DaughterBorad to MotherBoard CONN

Title	<Title>	
Size C	Document Number <Doc>	Rev <RevCode>
Date: Monday, June 02, 2008	Sheet 1 of 1

CardReader

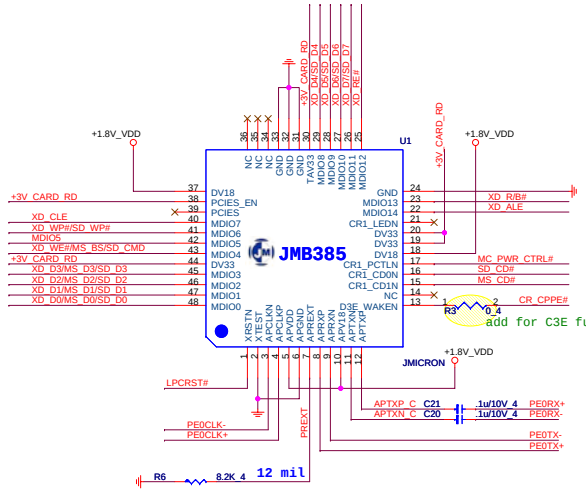
APVDD(pin5) must put C601/1000pF close to APVDD(pin5) (length must under 120mil) and trace width = 20mil, after C601, pls put one more 0.1uF for it.

PHONE JACK

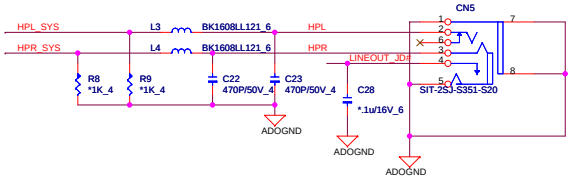
Use 0805 type and over 20 mils trace width on both side

Kill SW

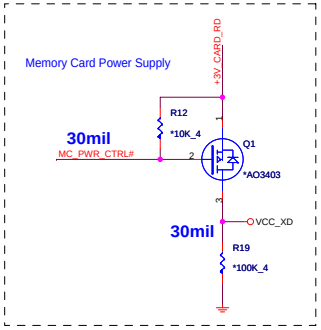
chnge pin sequence
